Gary Hunt Investments Pty Ltd  
ACN 627 072 584

CEO  
Douglas Shire Council

Attn: Neil Beck  
Ref: CA 2021\_4239/1 (1028000)

INFORMATION REQUEST  
(Given under Section 12 of the Development Assessment Rules)

TITLE		
HYDRAULIC SERVICES MASTER PLAN SANITARY DRAINAGE & PUMP STATION		
PROJECT NO.	DRAWING NO.	REVISION
20124	SK02	1

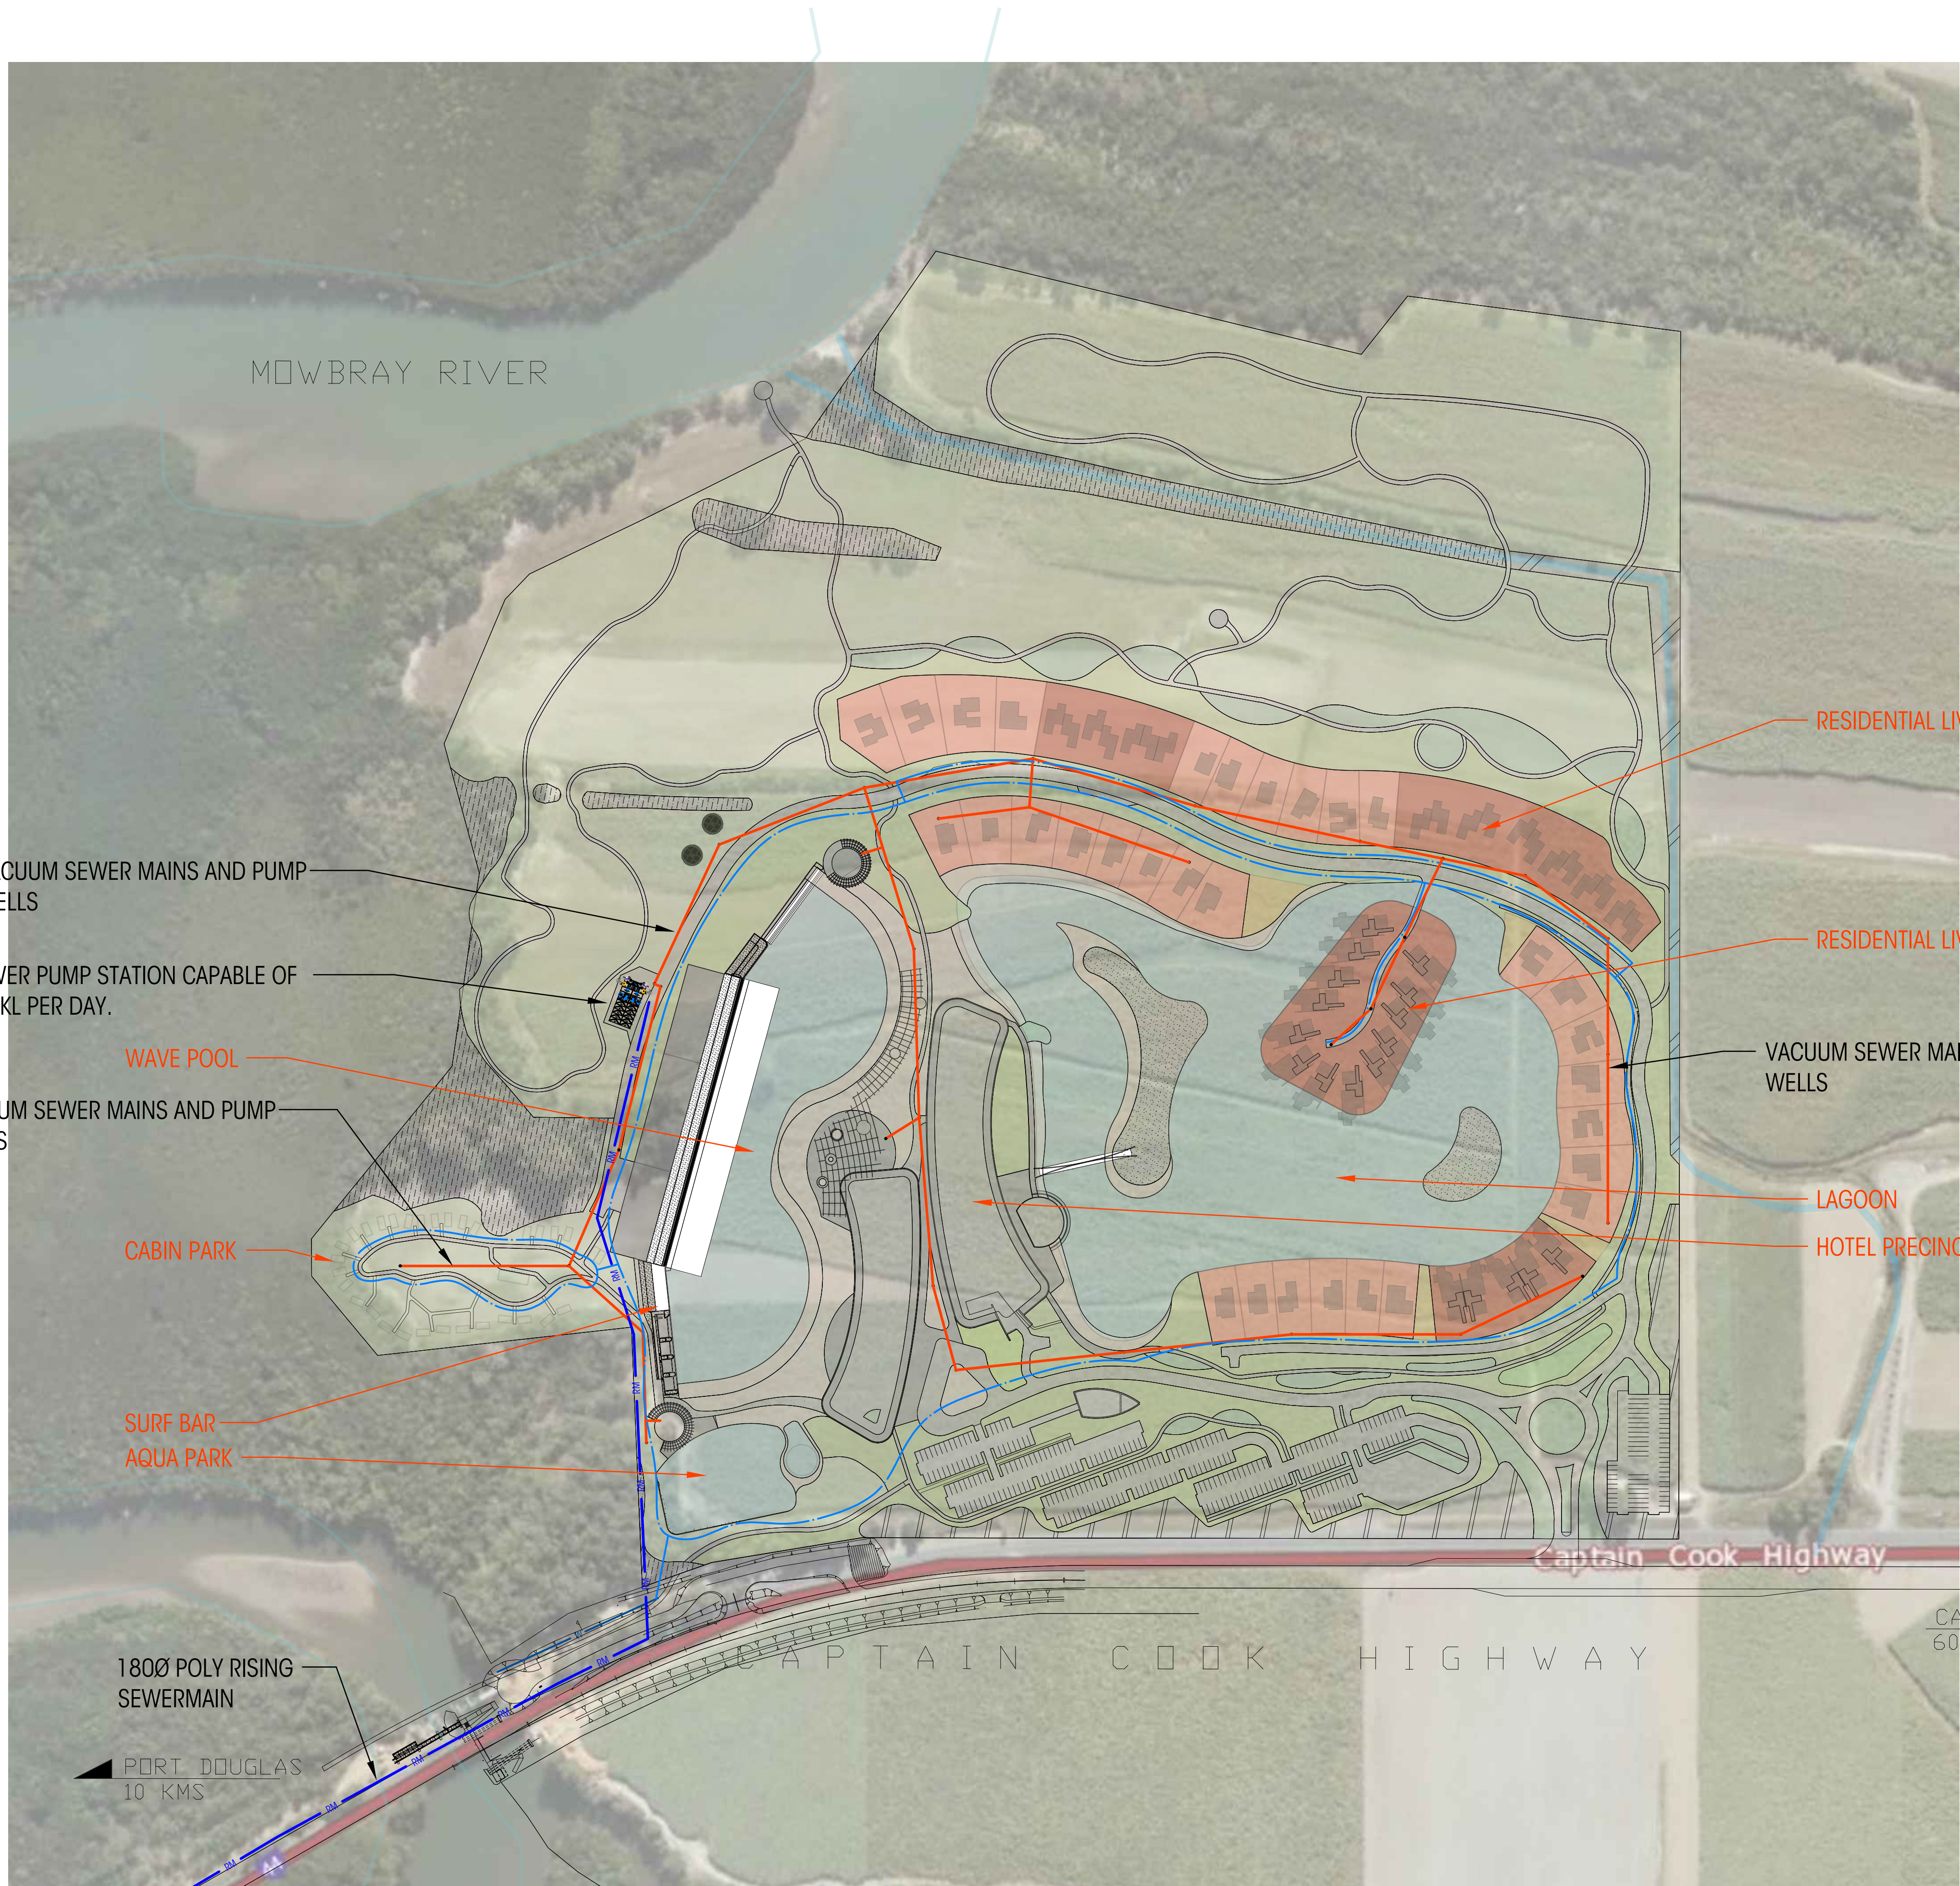
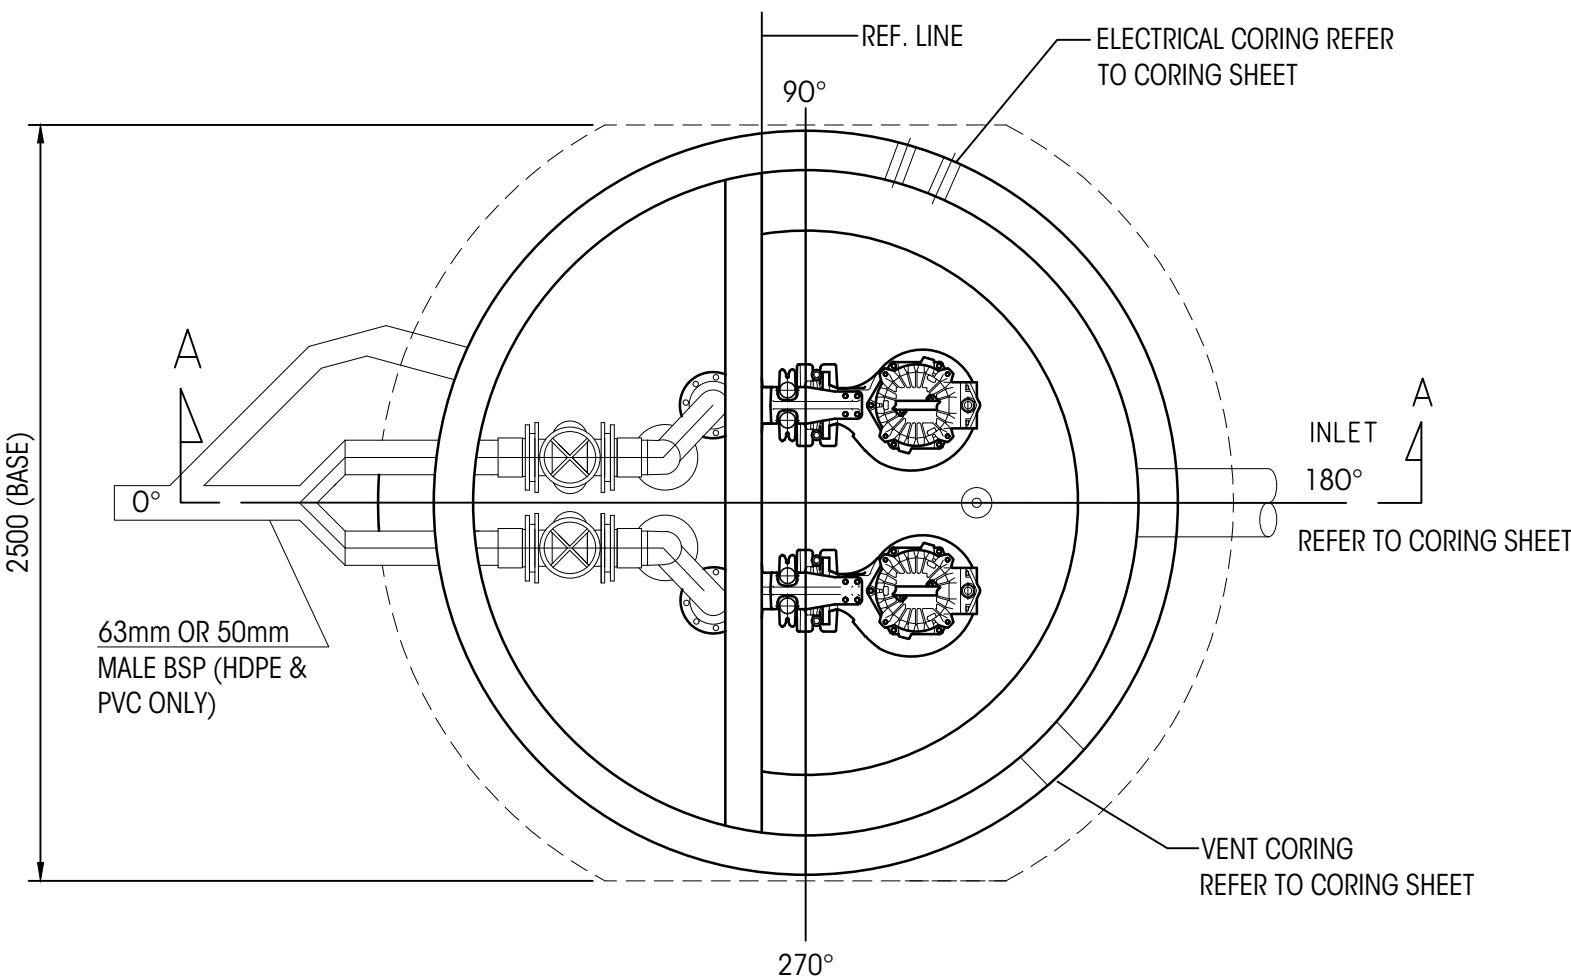
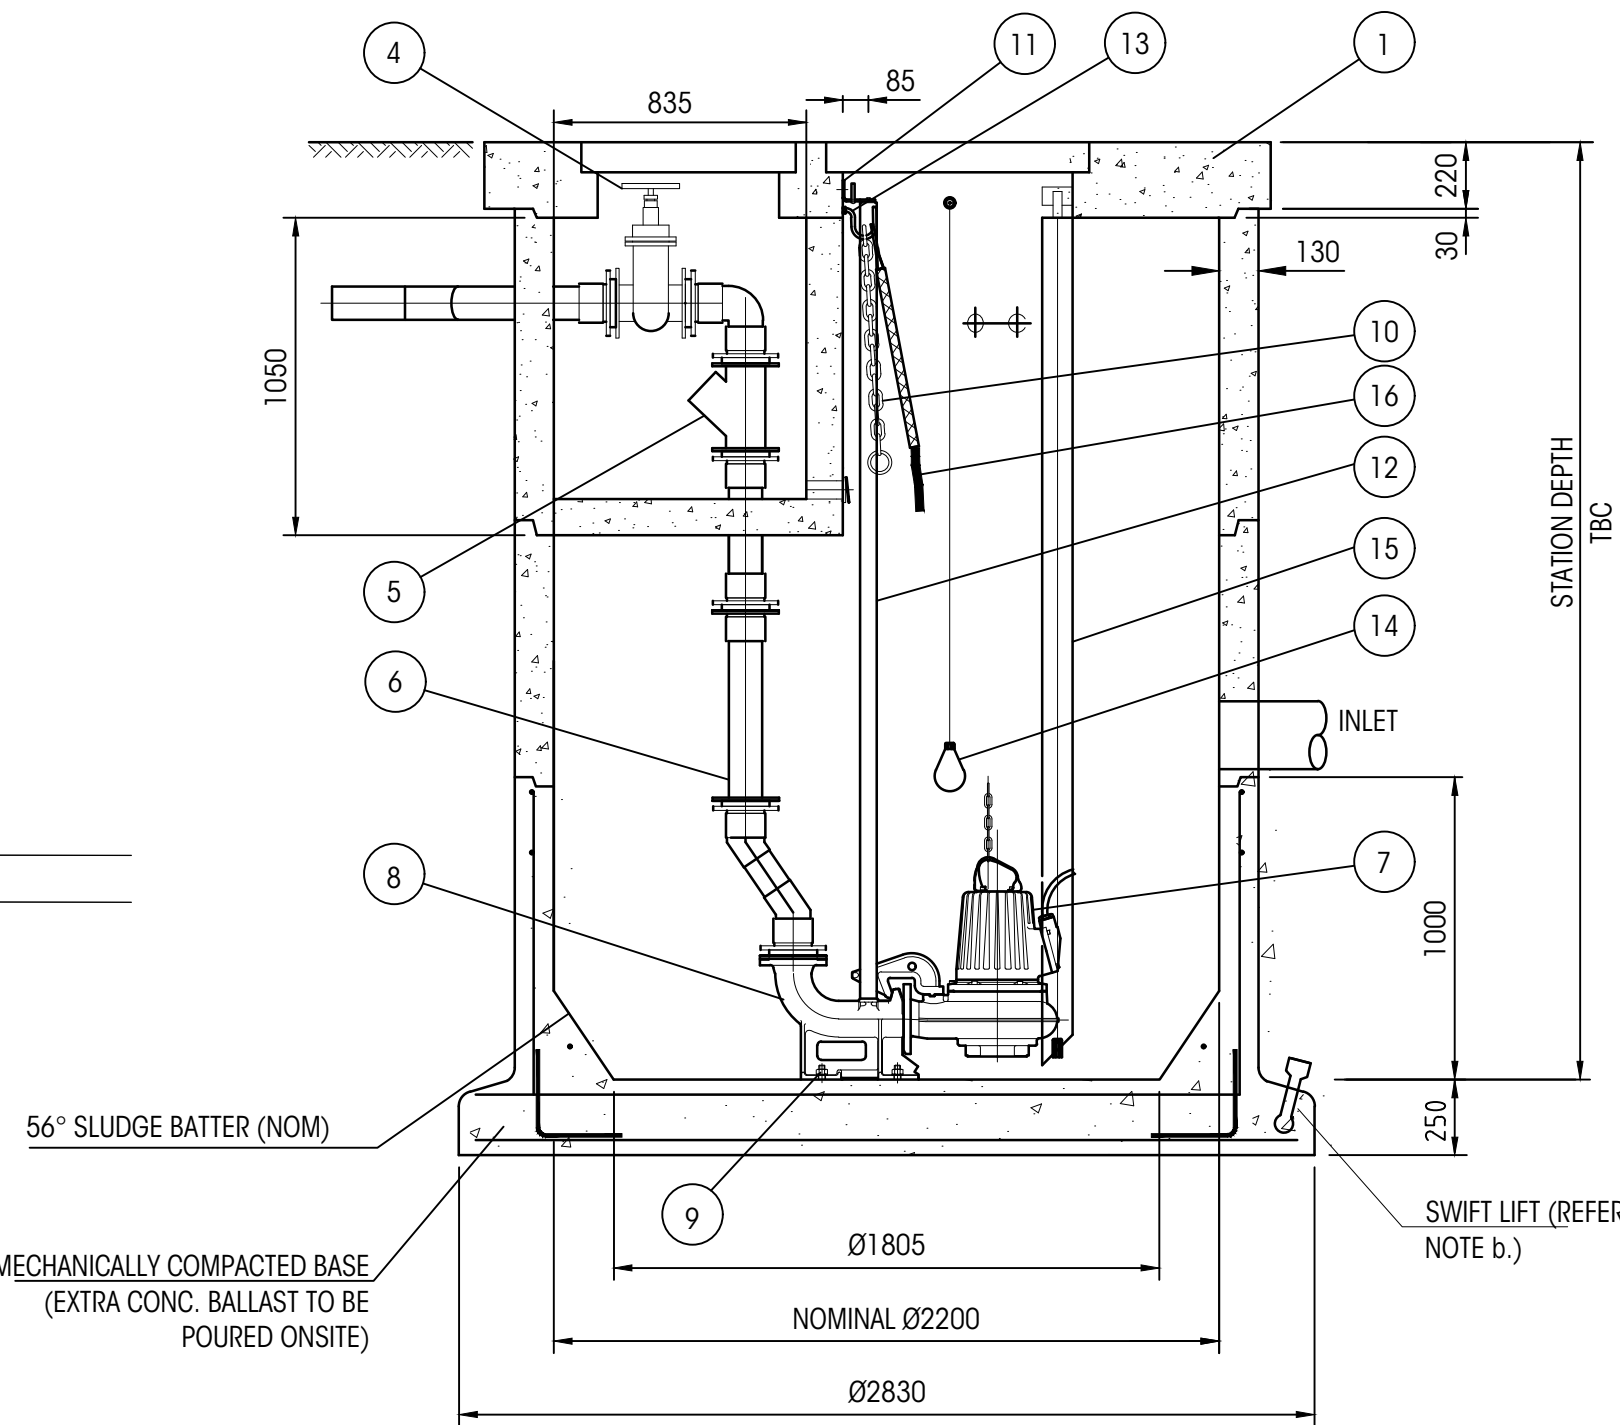
9. Provide sewage demand calculations for the sewage loads generated from each element of the development. The demands must be in accordance with FNQROC unless substantiated by appropriate detailed studies. Some of this work may be conditioned for later stages, however, appropriate clarity must be provided now to determine how the development will be connected to Council's reticulated network and the additional demand placed on the sewerage treatment plant.

The proposed sewer infrastructure internally of the Development is for a vacuum system, discharging to a Development Sewerage Pumping Station. Preliminary calculations indicate a 180mm poly (150mm UPVC) sewer rising main would run parallel to the Highway. The receiving manhole would require a 225mm Gravity Sewer connection. Further modelling would be required for the discharging sewer system. The Development Pump Station could be timed for the discharging into the council sewer network to happen outside peak times to alleviate any possible issues.
